KM Nobely Garments Ltd.

21st December 2020

Observations

Core layout plan

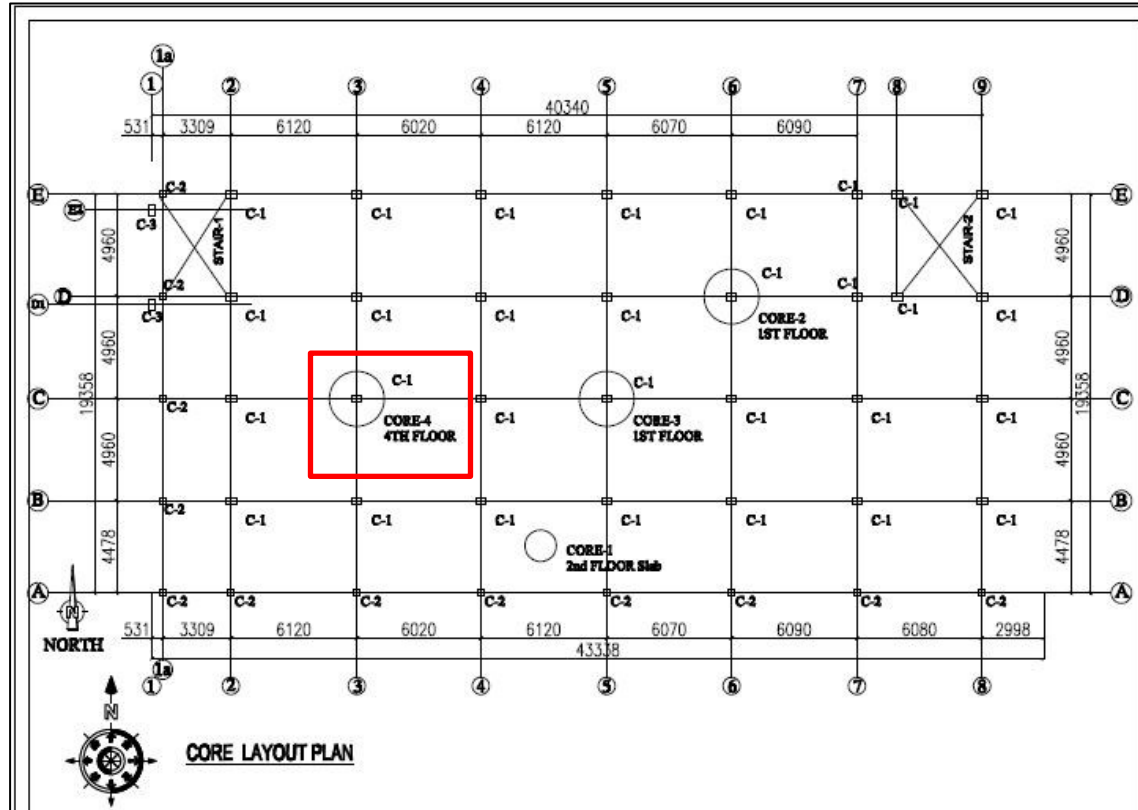
Total four number of concrete core samples are taken, three samples taken from column & one sample taken from slab. As per core layout plan one core sample was taken from the 4th floor column which is actually constructed for encasing the steel column for fire protection. Factory engineer is required to take minimum number of core samples from columns to evaluate concrete strength.

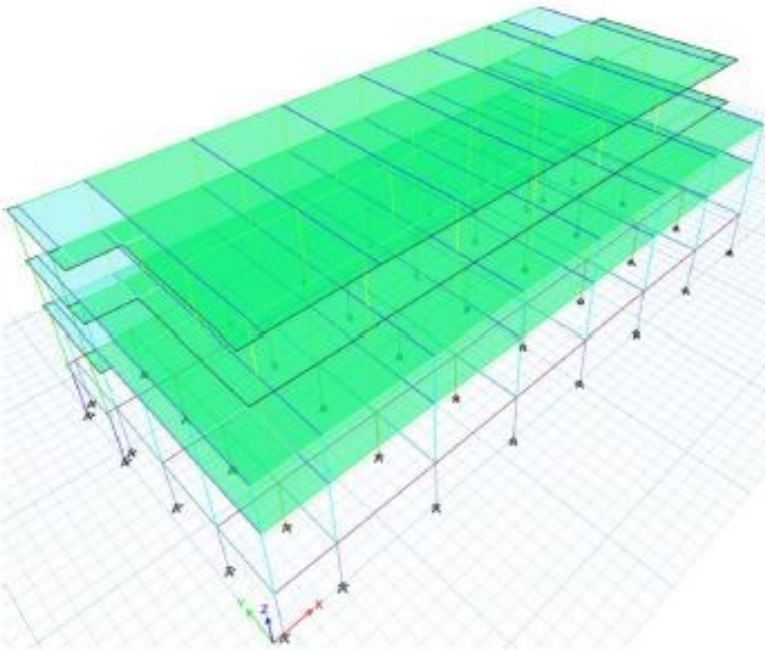
Overall stability of 3rd & 4th floor achieved by the frame action (Main beam in long direction, Sub-beam in short direction) & vertical bracings.

The connection of the frame could not be confirmed due to the RC encasement. Building engineer is required to check the connection type & requirement of any additional features. Serviceability and stability check in the design report is required to comply with BNBC.

**Apparently inadequate connection of steel cladding.
(Production Building)**

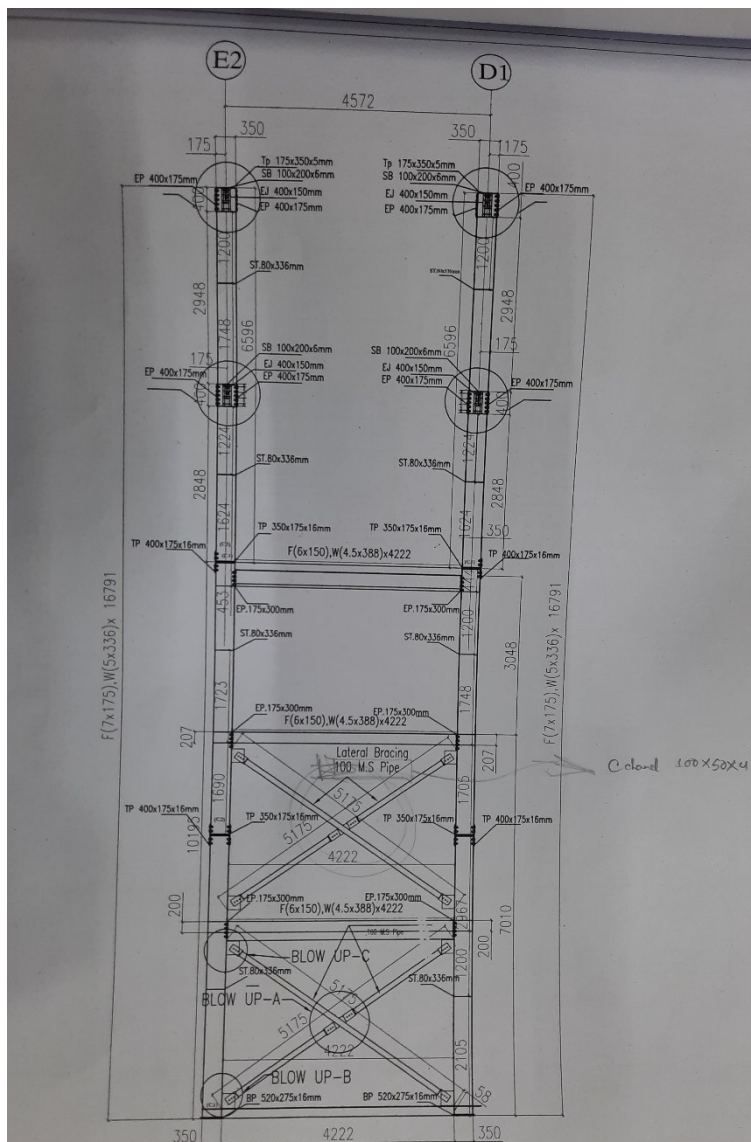
Apparently poor connection in the steel cladding system. Building engineer is required to check the connection adequacy against the wind loading.

Bracing elevation on drawing

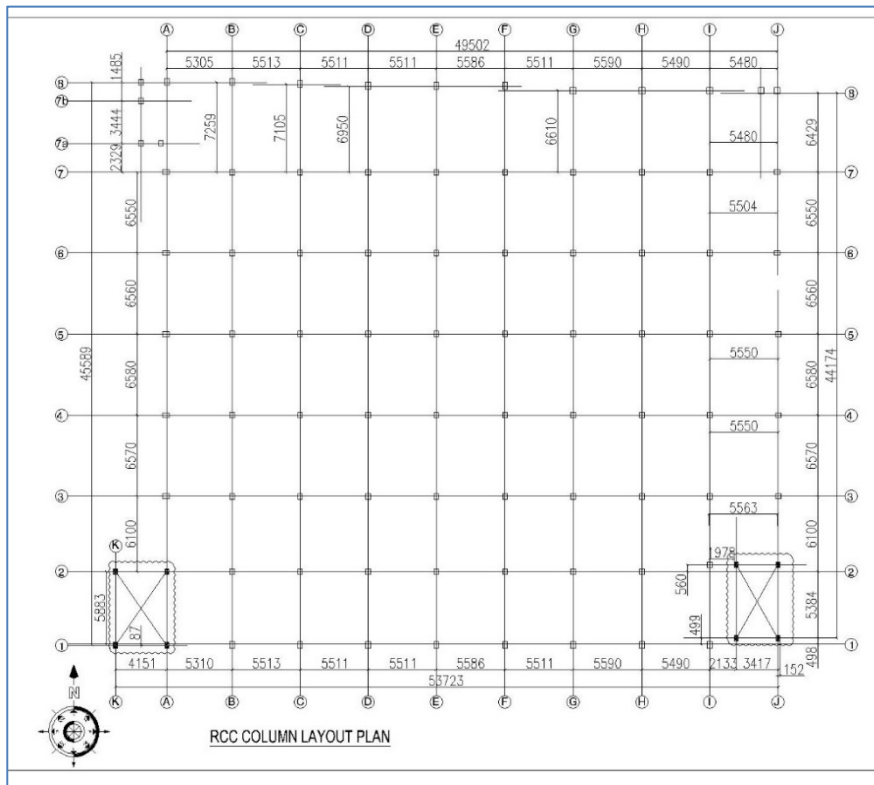
100 mm diameter pipe bracing shown on drawing, onsite C channel of 100 mm X 50 mm X 4 mm bracing was found.

RC column layout plan

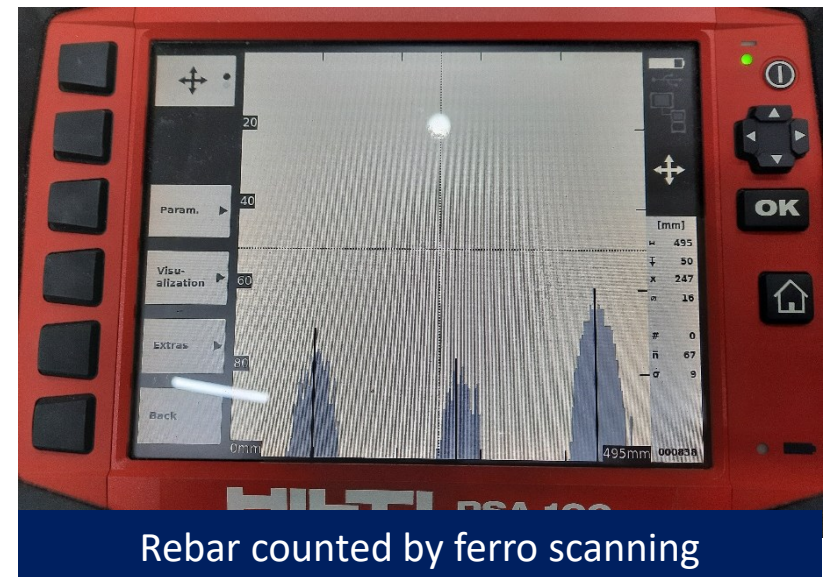
As-built drawing shows 12 number of rebars in the C5 column. But on site 8 number of rebars were counted by ferro scanning.
